Office Action Summary	Application No. 10/518,756	Applicant(s) YOKOYAMA ET AL.	
	Examiner PAUL T. CHIN	Art Unit 3652

DETAILED ACTION

7. Claims 18-20, 22, and 24 are rejected under 35 U.S.C. 102(b) as being anticipated by the Japanese patent (JP 02-100791) (see IDS).

Exhibit A

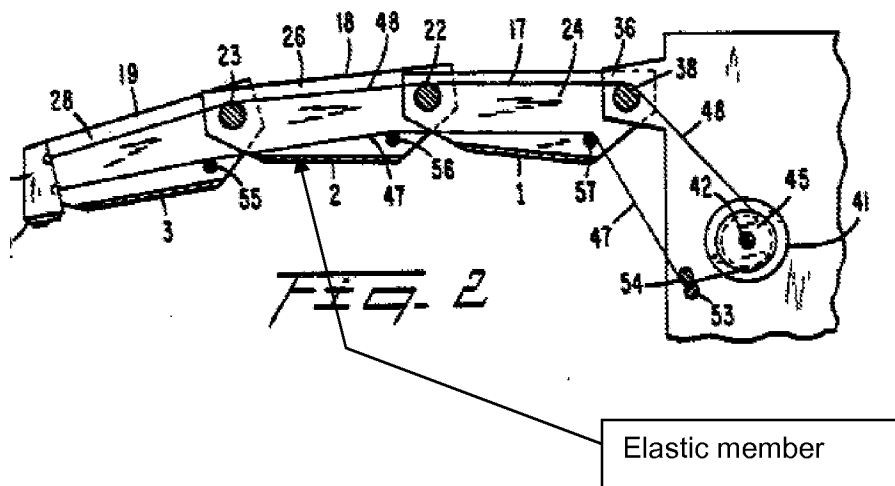
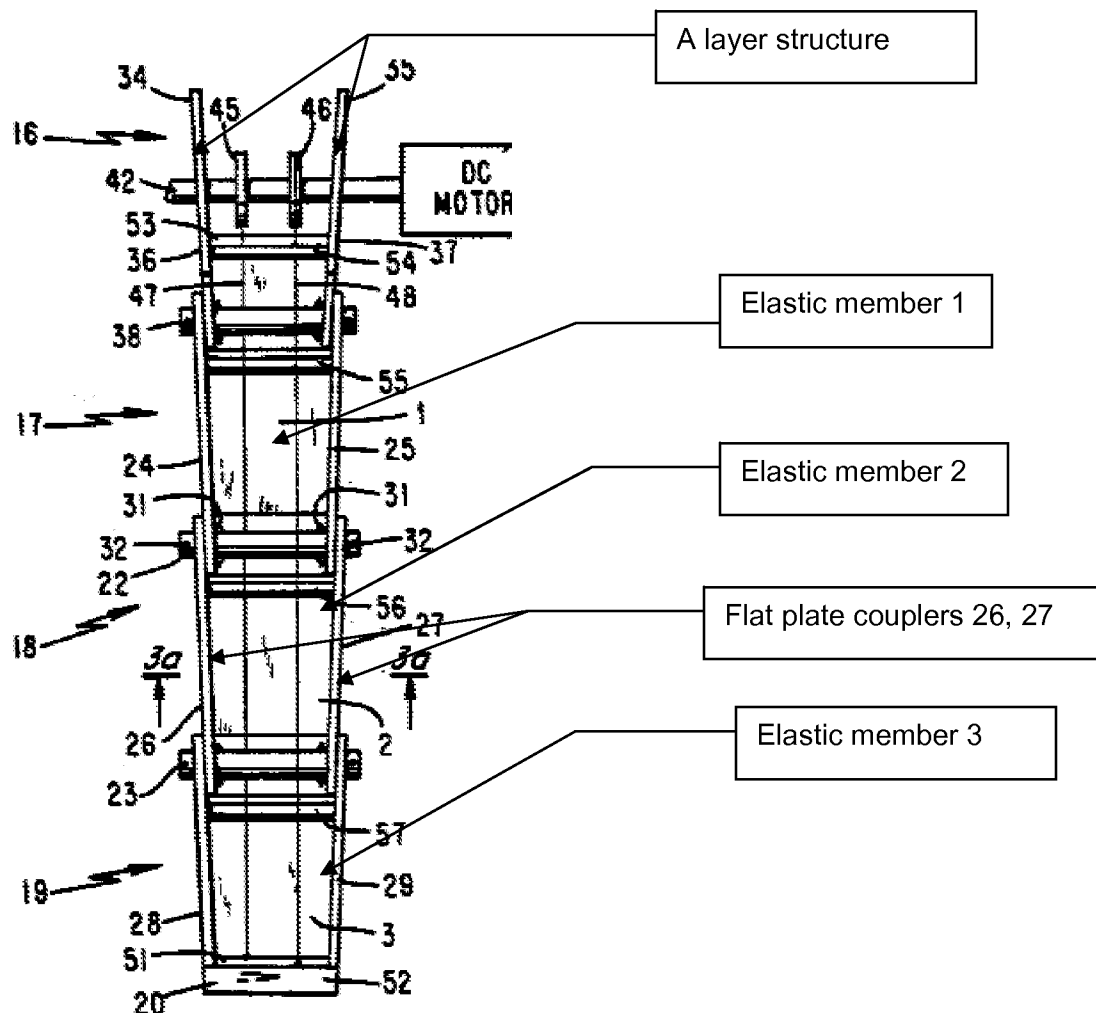
Applicant argues that "Graham (5,200,679) does not disclose elastic members which are arranged so as to stretch over the coupling portions" (page 10).

Note that the recited phrase "to stretch over the coupling portions" is a functional limitation. Graham (5,200,679) teaches coupling portions, which could be a pair of flat plates (26 and 27 of Fig. 3), or a pair of hinges (22 and 23), having flat ends, and webs (1, 2, 3), which are elastic members, as shown in figure 3. Note that figure 2 (see Exhibits A and B) teaches the elastic member substantially stretching over the plate (27).
